Access Compliance Report

Public Rights-of-Way

(Curb Ramps)

Intersection ID: 14349	Main Street: REMOUNT_RD	Cross Street: TOOMEY_AV	Location: S
ADA ID: 502DCE1C5A3F	Ramp Type: Perp	Initial Pass/Fail: Fail	Overall Compliance: No
Severity Score: 50			
Codes/Mitigation Info/Possible Solution		Field Measurements/Component Compliance

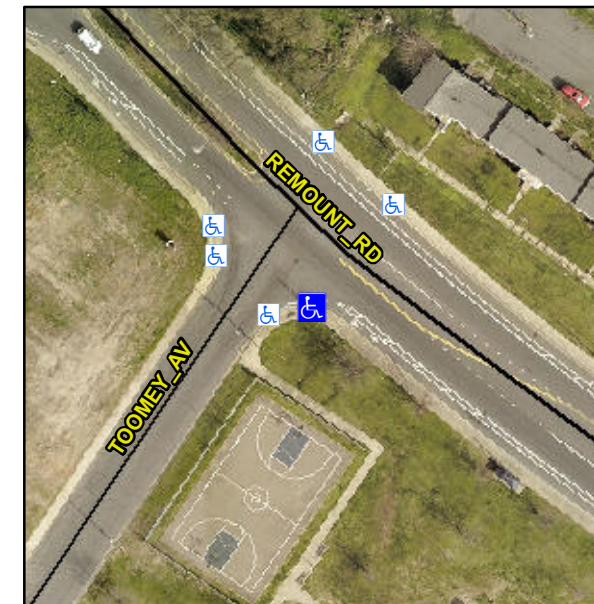
Not Found, R304.2.2, R304.5.3

Compliance	Description	Data	Compliance	Description	Data
N/A	Ramp Length (in)	60.0	No	Ramp Slope (%)	12.0
Yes	Ramp Width (in)	48.0	No	Ramp XSlope (%)	7.3
N/A	Flare Type LT	N/A	N/A	Flare Type RT	N/A
N/A	Flare Slope LT (%)	N/A	N/A	Flare Slope RT (%)	N/A
N/A	Flare Traversable LT?	N/A	N/A	Flare Traversable RT?	N/A
N/A	Landing Length (in)	N/A	N/A	DWS Provided?	N/A
N/A	Landing Width (in)	N/A	N/A	DWS Contrast?	N/A
N/A	Landing Slope (%)	N/A	N/A	DWS Length (in)	N/A
N/A	Landing X Slope (%)	N/A	N/A	DWS Full Width?	N/A
N/A	Landing Curb? (Y/N)	N/A	N/A	DWS Offset (in)	N/A
N/A	Shared Landing?	N/A			
N/A	Gutter Ponding?	N/A	N/A	Gutter Slope (%)	N/A
N/A	Gutter Lip Ht (in)	N/A	N/A	Gutter X Slope (%)	N/A
N/A	Painted X Walk1?	No	N/A	Painted X Walk2?	N/A
	X Walk 1 Direction	To NE		X Walk 2 Direction	N/A
N/A	X Walk 1 Width (in)	N/A	N/A	X Walk 2 Width (in)	N/A
	X Walk 1 Slope (%)	1.4		X Walk 2 Slope (%)	N/A
	X Walk 1 X Slope (%)	2.8		X Walk 2 X Slope (%)	N/A

Remove & Replace Entire Ramp.
